# **ADDENDUM NO. 1**

**July 8, 2020**

**PHYSICS 2000 RENEWAL**

**PROJECT NO. 957443**

**A1** (E) 1st FLOOR PLAN - DEMOLITION

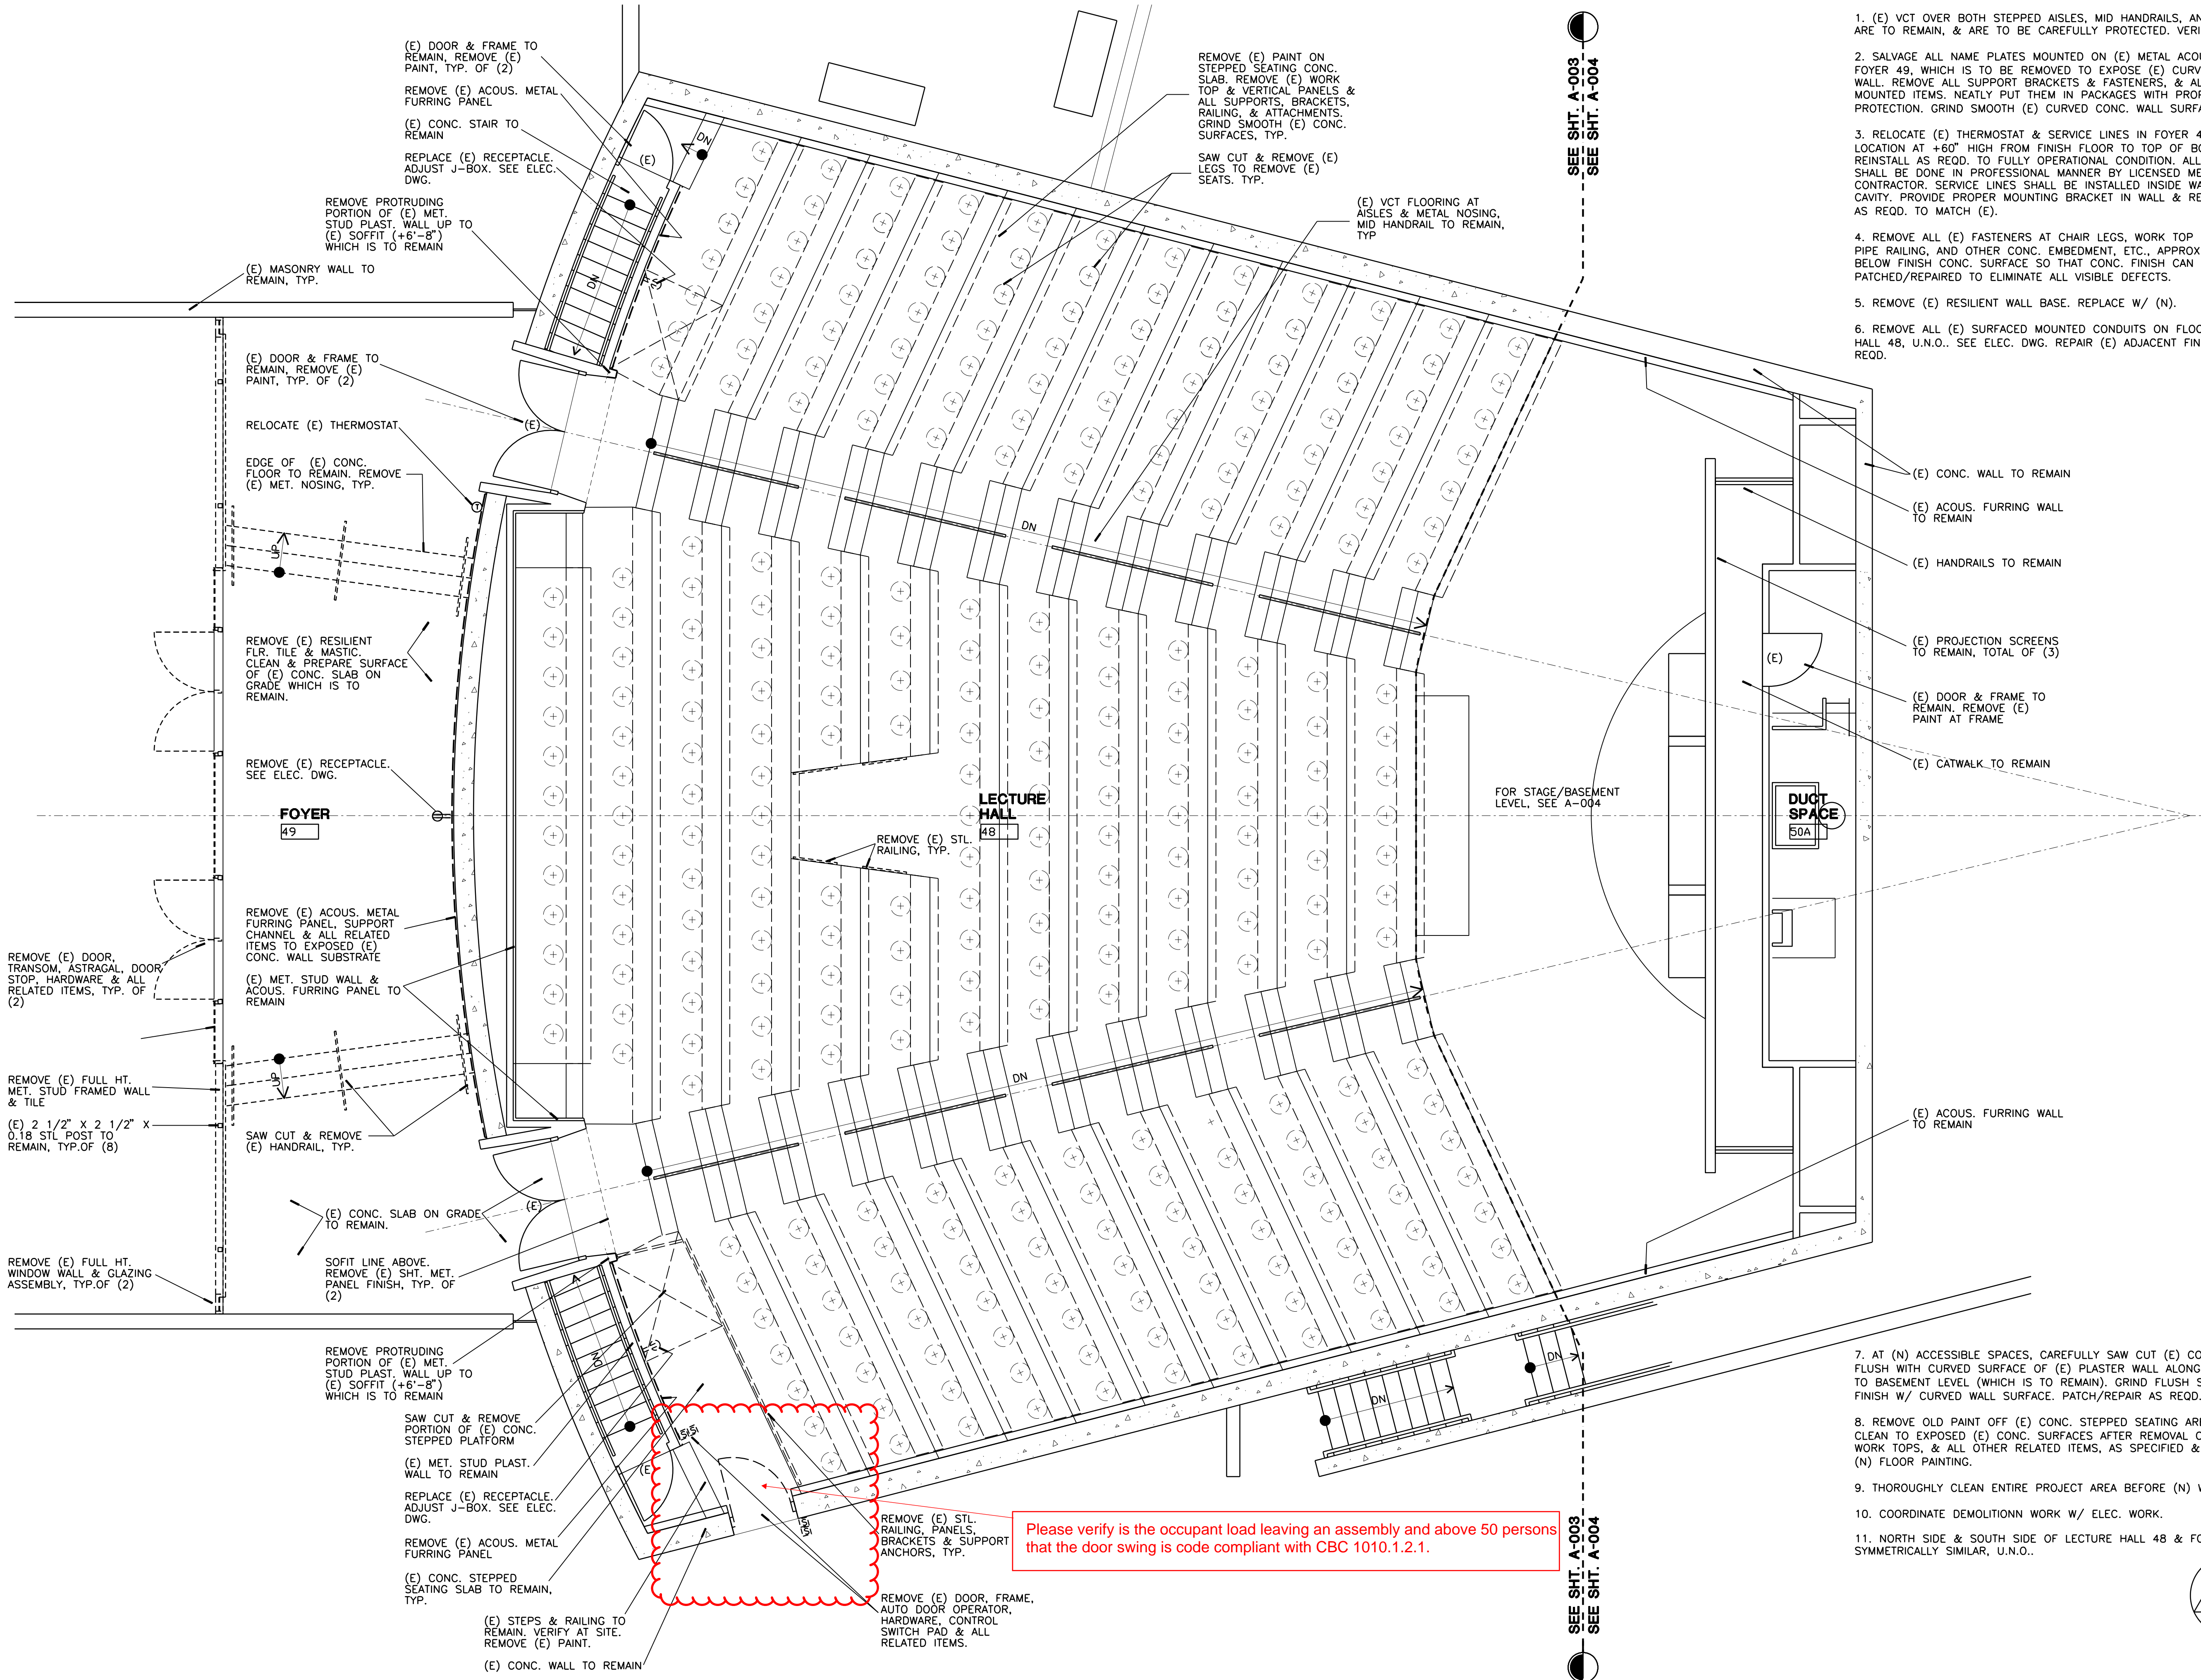
Please verify is the occupant load leaving an assembly and above 50 persons that the door swing is code compliant with CBC 1010.1.2.1.

### SEATING LAYOUT - OPTION 2

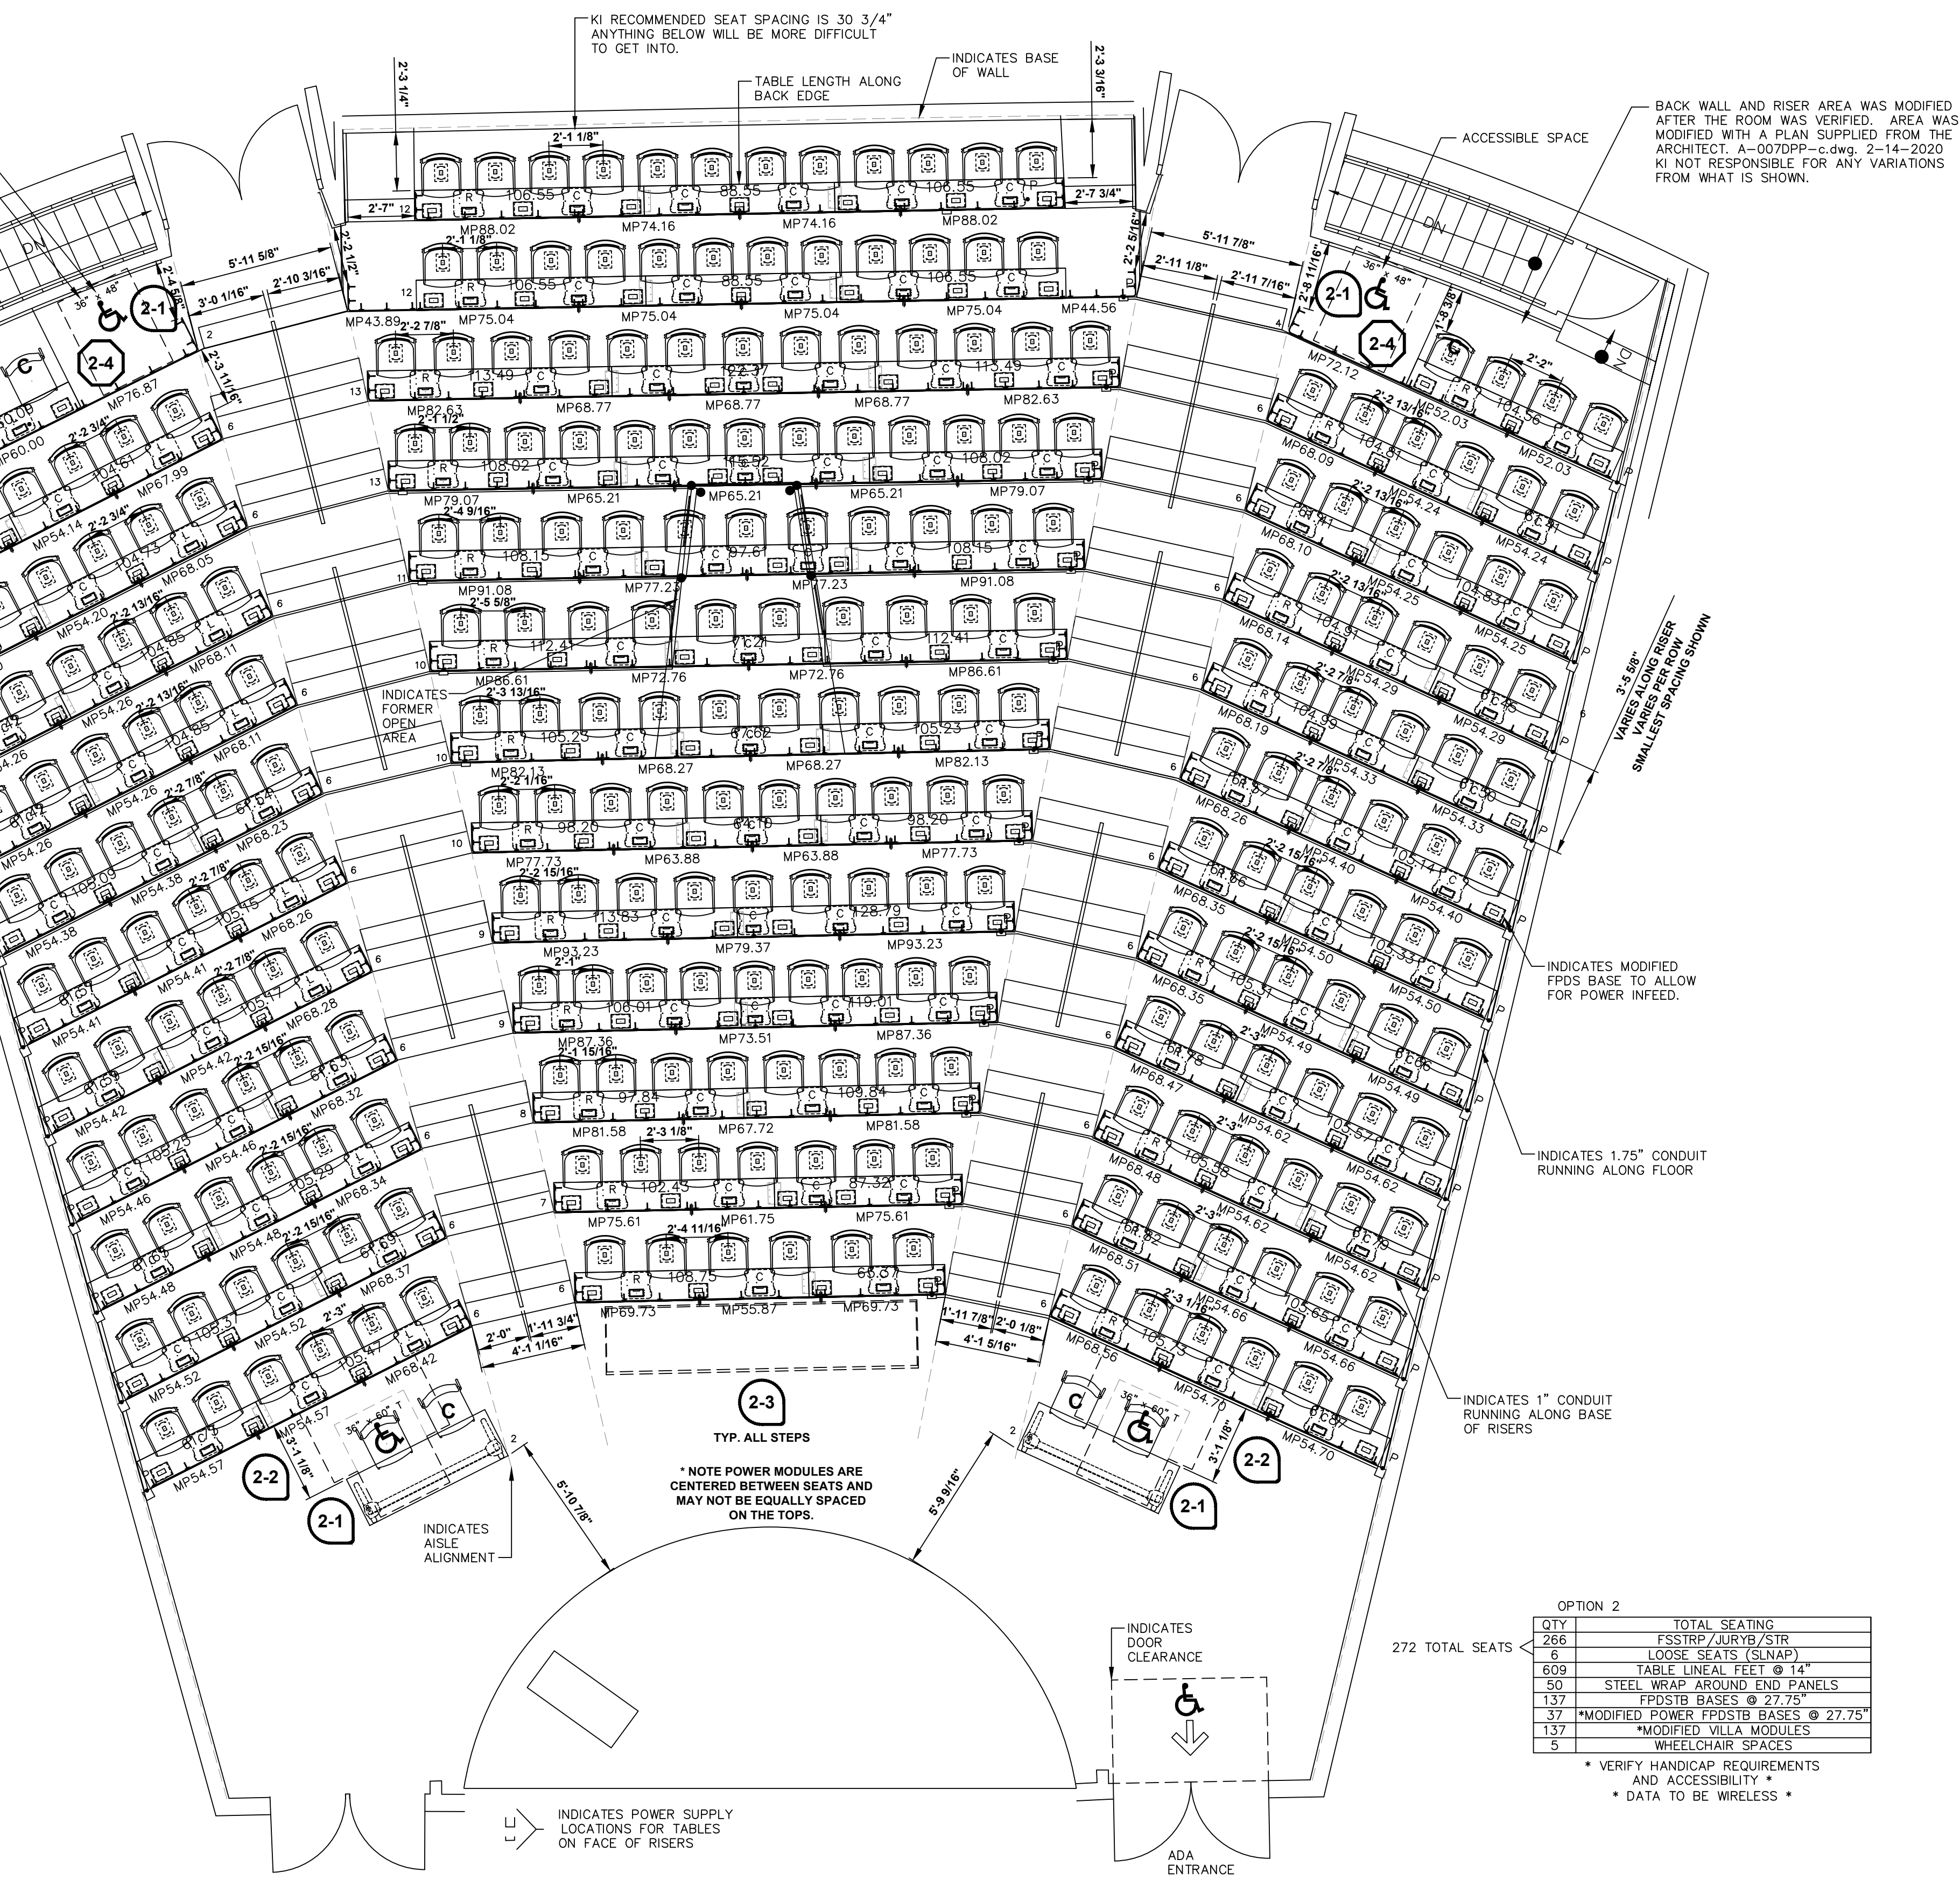
PLEASE VERIFY IF THE FLOOR OF THIS ACCESSIBLE ROW IS ALL ON THE SAME LEVEL.
